**RE: 601 Capitol Mall Mixed-Use (P18-054)**

The revised plans for 601 Capitol Mall Mixed-Use (P18-054) incorporated two of the recommendations we made in our September 25, 2018 letter. The changes were made on the first level and will influence residents to use the stairs rather than the elevator for internal trips. This could increase the amount of daily physical activity for residents and benefit their health.

*Revised South Stairwell*

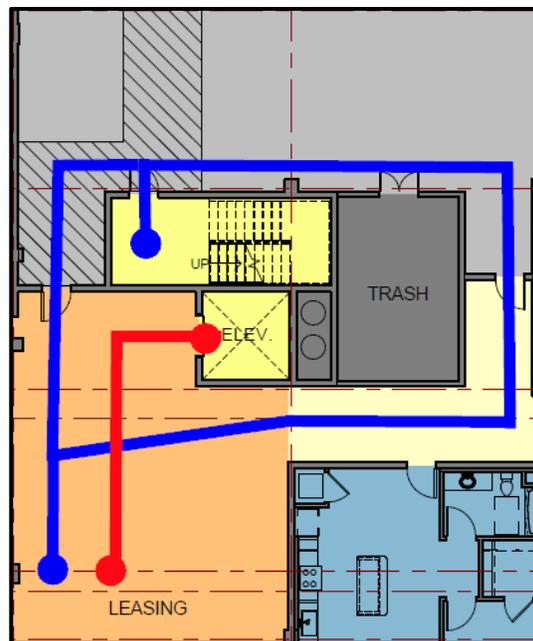
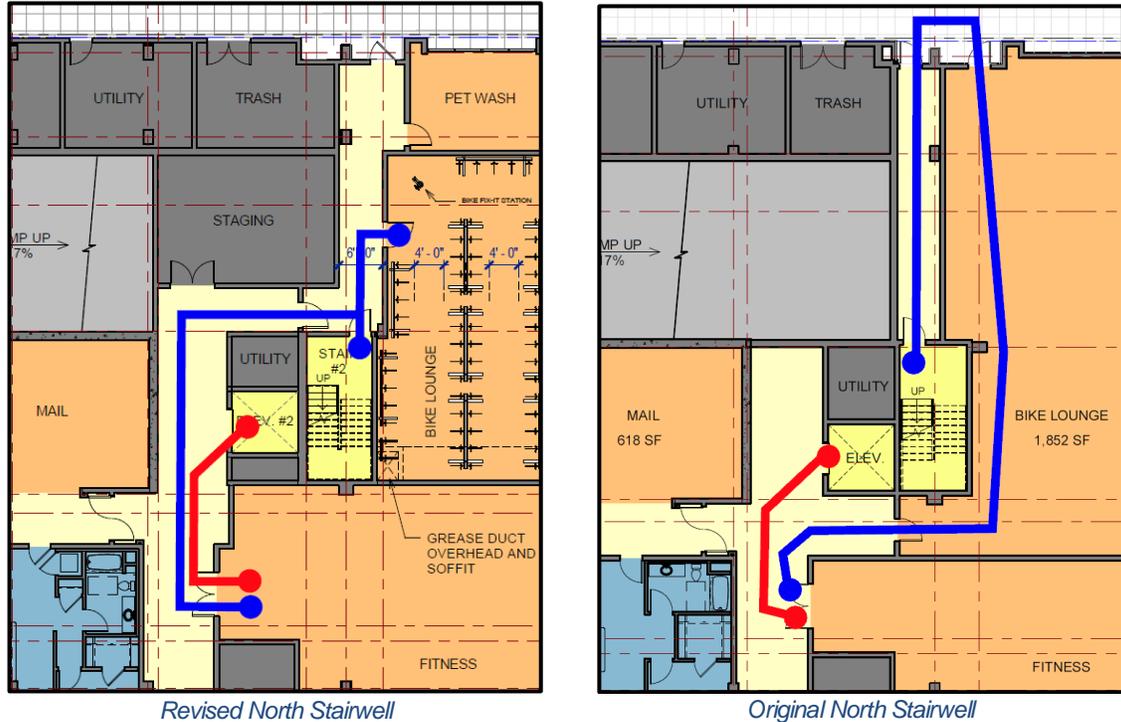
✓ **Move the ground-level door for the south stairwell so it opens into the Leasing area space.** The revised plans incorporate a second stairwell door that opens directly into the leasing area and the lounge/lobby area. The door is within several feet of the elevator, so residents will have an obvious choice between using the stairs or the elevator. The figures below show the direct stairwell access routes in the revised plans on the left, while the original routes are shown on the right.

*Recommended Bicycle Travel Path (Blue Line)  
Implied Bicycle Path of Travel (Red Line)*

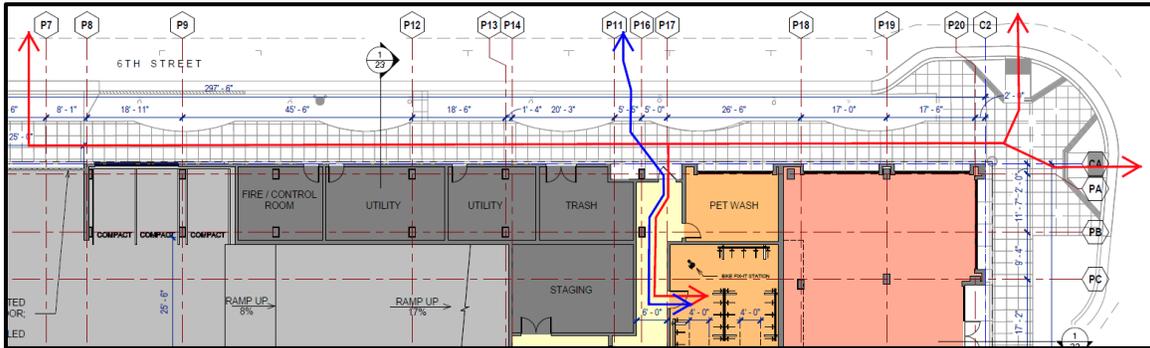
- ✘ **Locate the north stairwell doors on levels 2-8 in the main north-south hallway or as close as possible to the elevator.** No changes were made.
- ✘ **Locate the south stairwell doors on levels 3-8 in the main north-south hallway or as close as possible to the elevator.** No changes were made.
- ✘ **Move the Bike Lounge close to the garage driveway.** Since the Bike Lounge wasn't moved close to the garage driveway in the garage, bicyclists will be using the sidewalk to access the street at either the garage driveway to the south or the corner curb ramps to the north. (Expected bicycle travel path is the red line in the figure on the next page.)

The street curb is continuous between the driveway and the corner, with on-street parallel parking spaces except at the fire hydrant. The sidewalk travel to the driveway or corner will be inconvenient, while the vertical curb and parked vehicles will make it inconvenient to take the shortest route directly across the sidewalk to the street.

- We recommend providing a narrow driveway-style ramp for bicycles and removing one vehicle parking space at the 6<sup>th</sup> Street curb across the sidewalk from the door that provides access to the Bike Lounge.
